FULTON COUNTY

Re: #16ITB091416K-JD Chattahoochee III Pump Station Upgrades

This Addendum forms a part of the contract documents and **modifies** the original documents as noted below:

DRAWING DATE: 06/28/2013
 DRAWING SCALE: AS SHOWN
 PROJECT NUMBER: 2015-0028
 DRAWING NUMBER: **H-401**

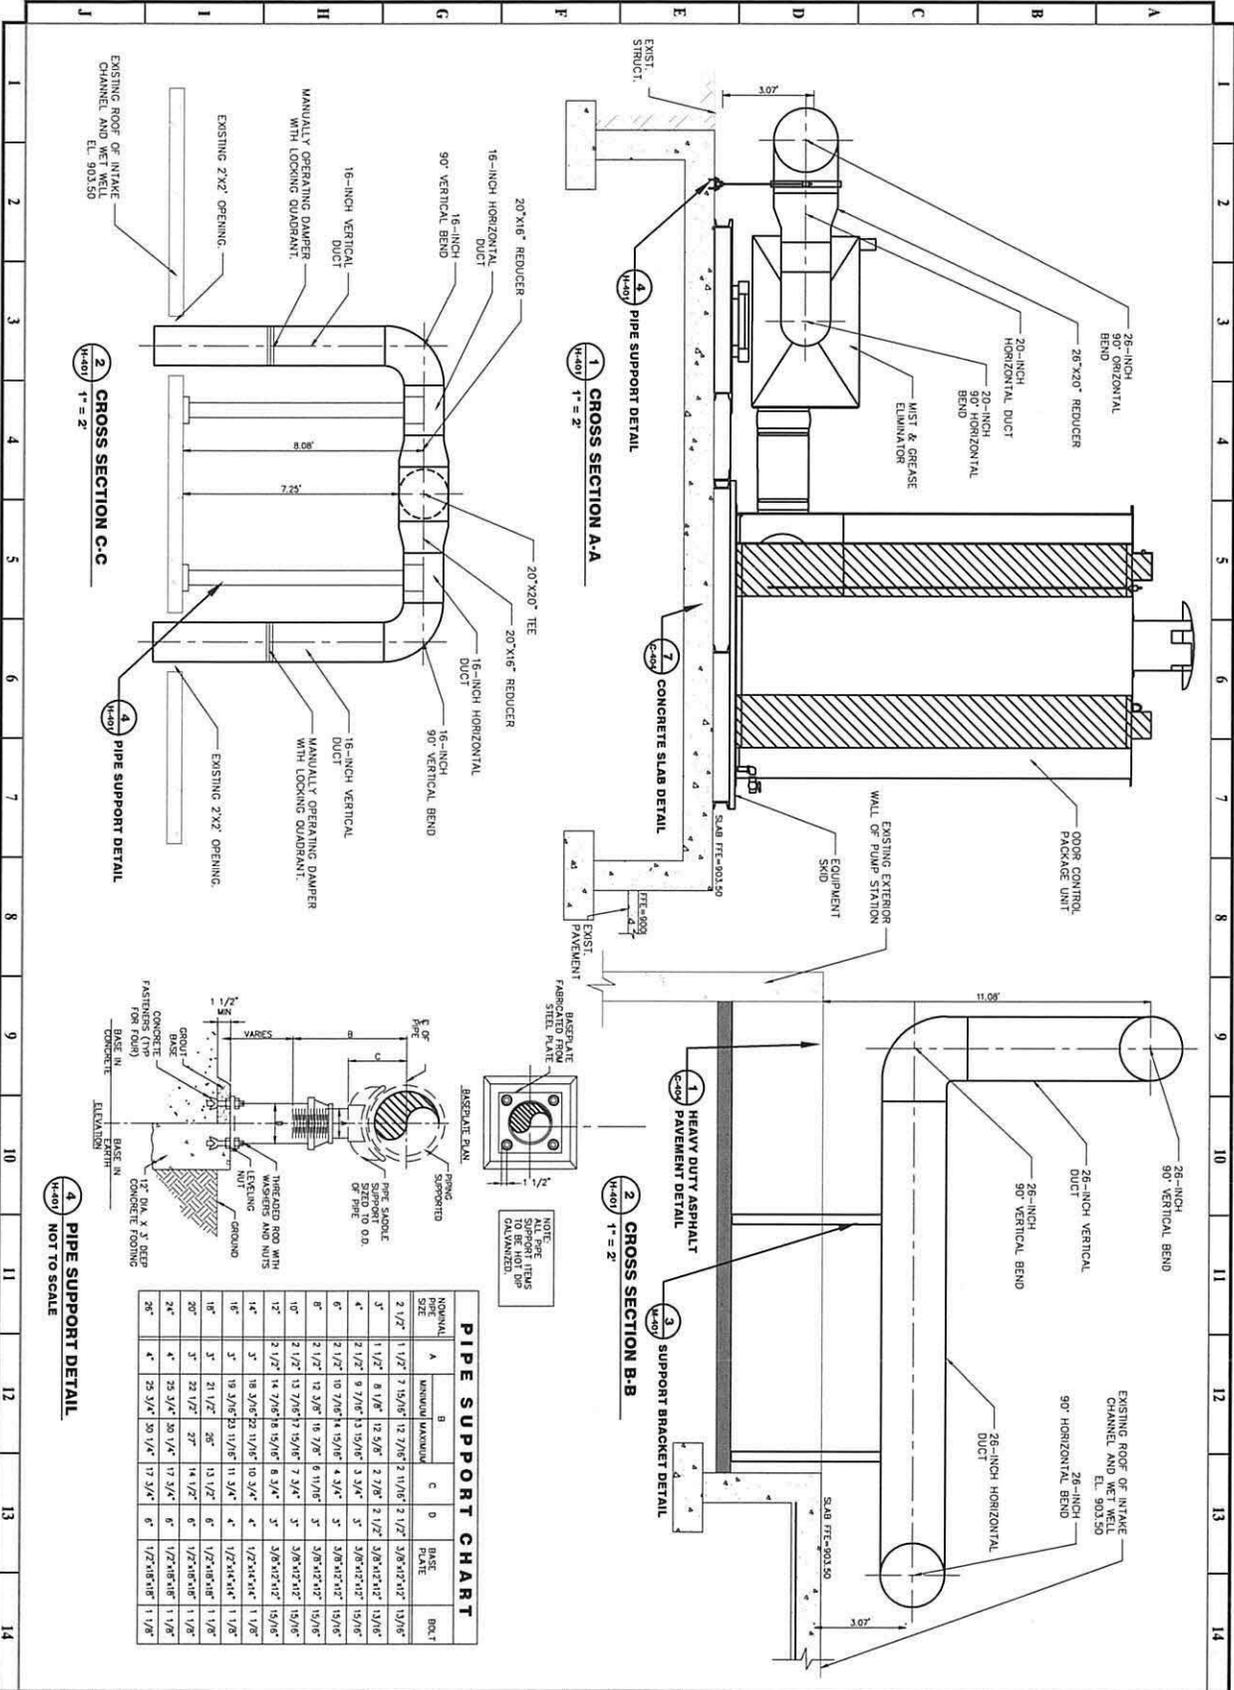
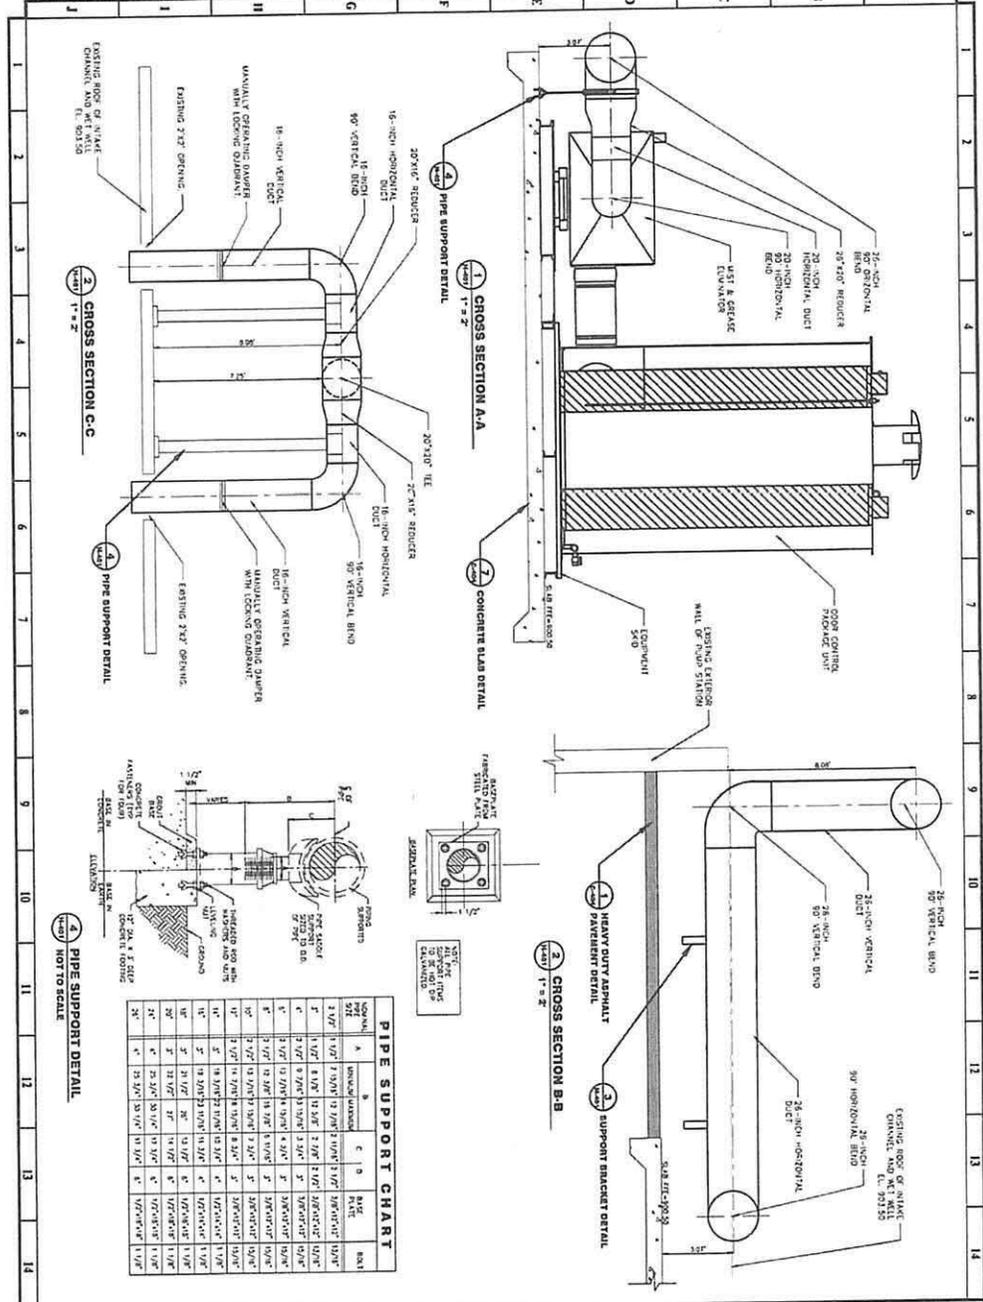
Relative to the layout on H-202 and H-401

The Mist / Grease eliminator in these drawings do not show the location of any access doors. Based on the cross-sectional width of the prefilter ECS would recommend that the unit have two (2) access doors so operators do not have to reach inside the prefilter.

The radial flow carbon adsorber vessel appears to have four small hatches on top for media access. It has been our experience that for tall vertical beds larger access doors are necessary for proper removal of the media. Standard ECS units include large crescent access doors (see the attached detail) which when removed expose at least 75% of the carbon bed. Please consider adding this requirement to the specification and / or the detail drawing.

1) 1.06, C, 11 mentions dispersion out of the exhaust stack with an exit velocity of 40 fps. The drawing seems to show an antiquated rain cap style which will prevent any dispersion and put the effluent air back down onto the equipment directly ECS recommends using a SMACA high velocity dispersion stack with over-cap rain guard. This design will not impede the effluent airflow from the stack and allow for the intended dispersion.

RESPONSE: Specifications 13500, Item 2.16.0 calls for doors (plural). (2.16) In the past Fulton county has required hinged access doors with stainless steel quick clamps to facilitate easy removal of the pad. Are the quick clamps required or are bolt-on access doors acceptable? RESPONSE: Hinged access doors are specified in speciation 13500, Item 2.16.0. This should include stainless steel quick access clamps.

RESPONSE: Access doors shall be adequate for easy removal of carbon bed.

RESPONSE: A SMACNA high velocity dispersion stack with over-cap rain guard shall be provided.

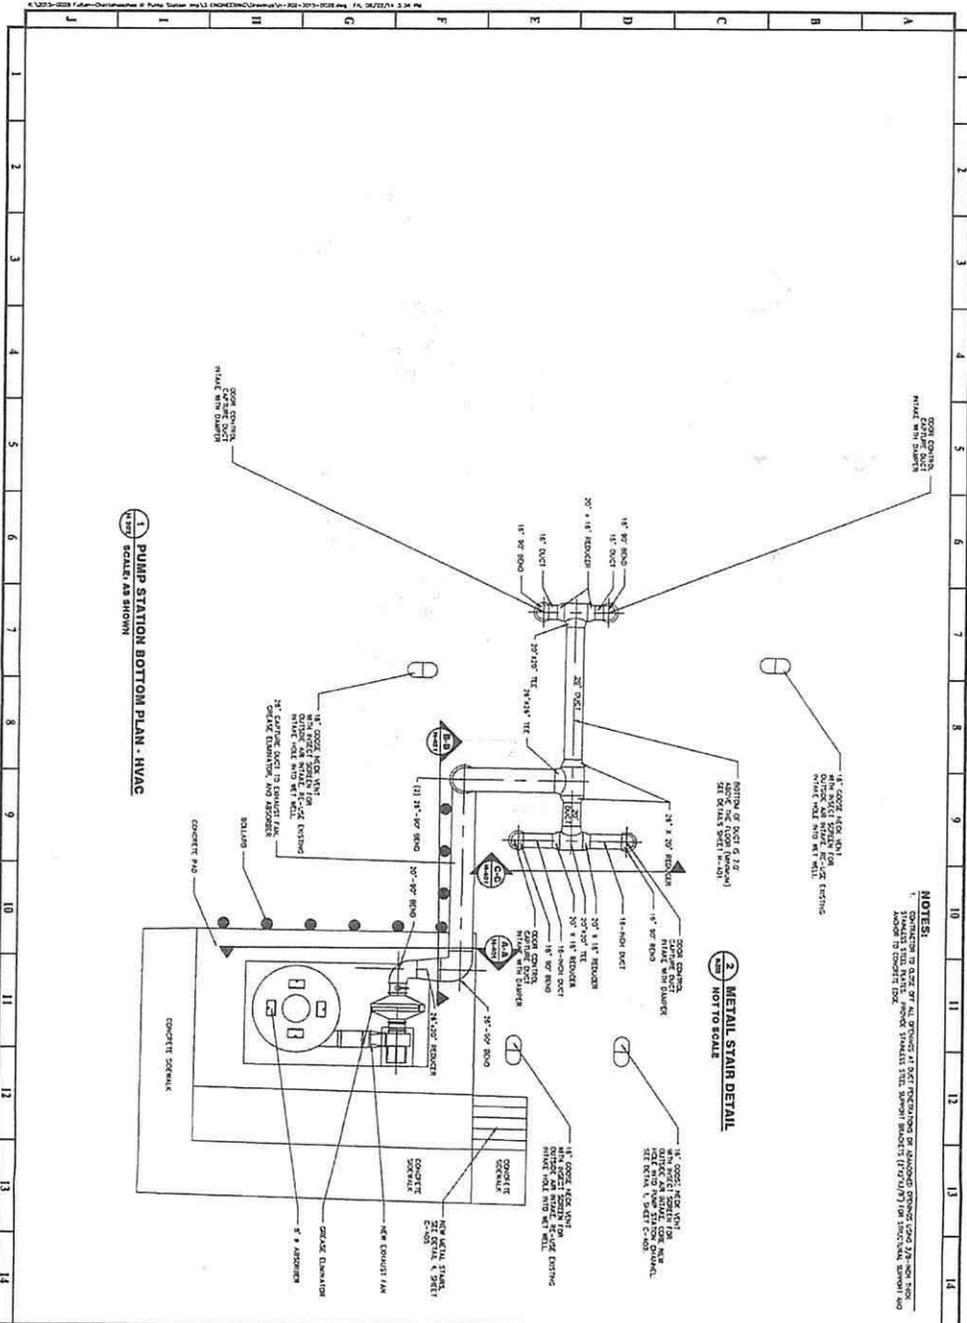
The inlet and outlet transitions on the prefilter are too steep. Air traveling into the unit will not have a chance to evenly disperse over the pad surface. ECS would

recommend that the damper shown on the inlet of the unit on H-202 be moved to a different location and the inlet transition into the prefilter unit be extended. If necessary ECS will send a detail of the suggested layout necessary to accomplish proper airflow distribution over the pad surface.

2.03, M states that a flow control damper should be installed between the fan outlet and the vessel inlet but it is not shown on the drawing. Please confirm if it is necessary.

RESPONSE: The inlet and outlet transitions may be modified to ensure performance guarantees.

RESPONSE: The drawing shows the damper incorrectly. It should be between the fan and vessel as specified on specification 13500 Item 2.03M.
